Rate Limiter Installation

Balaji Prabhakar and Rong Pan

Proposed Pseudo Code Modification

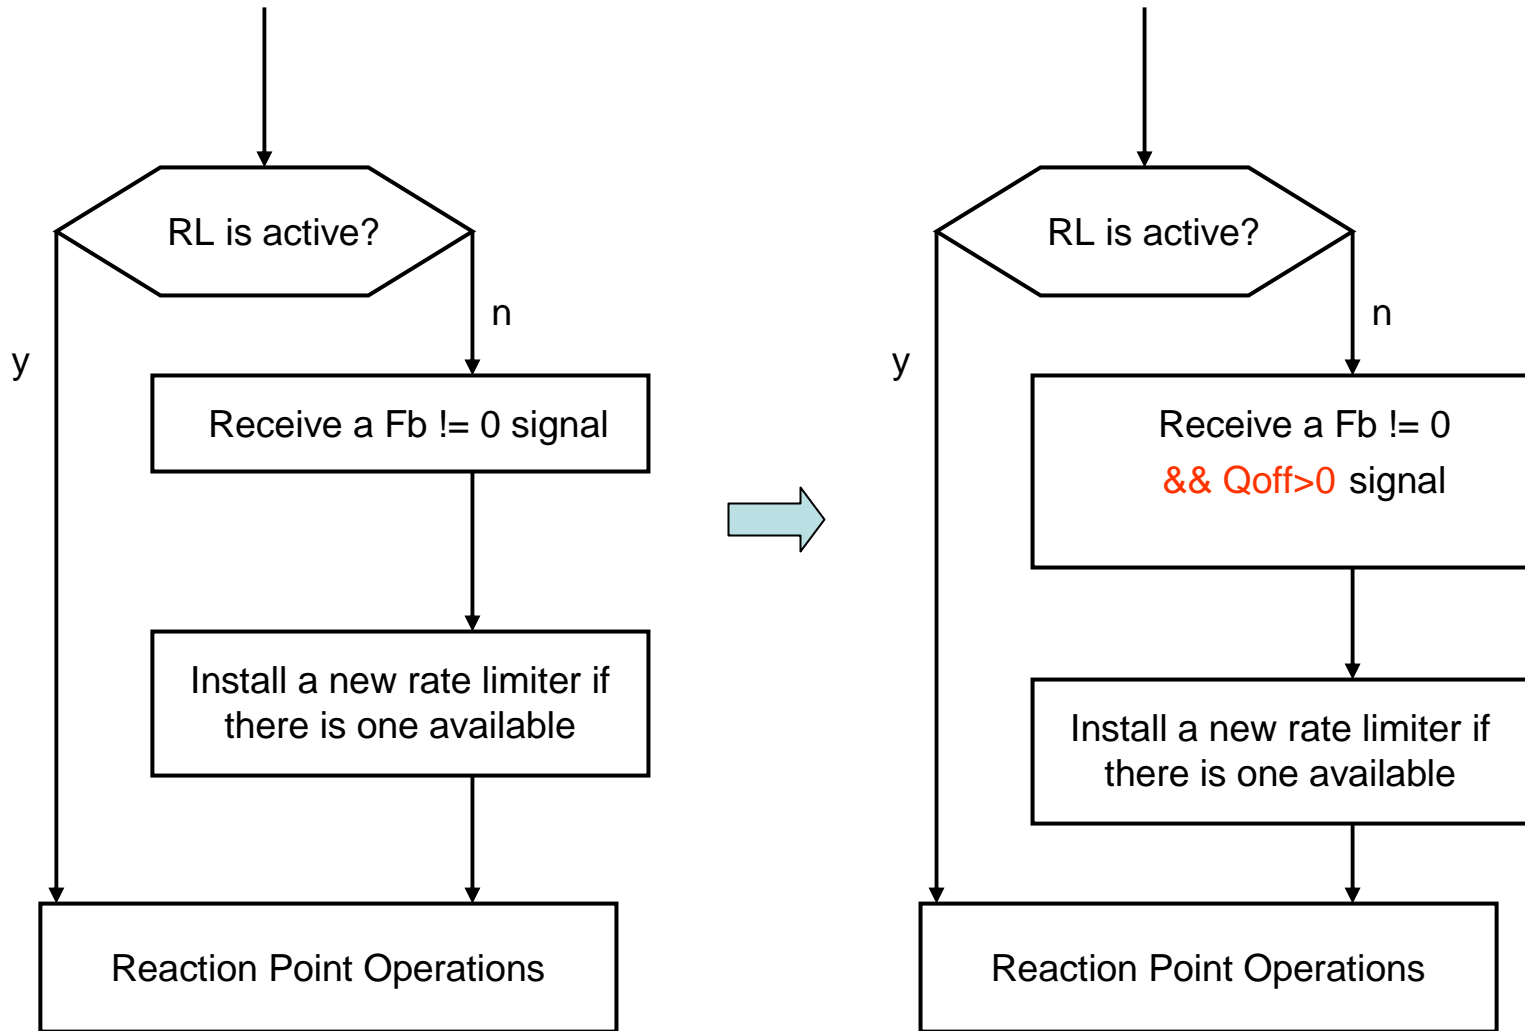
- A new L2 flow, for which an RL has not been installed, currently gets an RL the first time it gets an $Fb < 0$ message from the network
- As pointed out by Guenter Roeck and Mitch Gusat, this can cause unnecessary rate limiter installations
 - Because $Fb < 0$ can happen even when $Q_{len} < Q_{eq}$ (equivalently when $Q_{off} < 0$)
- Suggested change: install RL only if $Q_{off} > 0$ and $Fb < 0$
- We show the exact change in the p-code

```
if (RL[rldix].state == INACTIVE) then
  if (FBFrame.fb != 0 && Qoff>0) then
    //initialize new rate limiter
    RL[rldix].state = ACTIVE;
    RL[rldix].flowid = FBFrame.flowid;
    RL[rldix].crate = C;
    RL[rldix].trate = C;
    RL[*].tx_bcount = BC_LIMIT;
    RL[rldix].si_count = 0;
  else
    //ignore FBFrame
    return;
  endif
endif
```
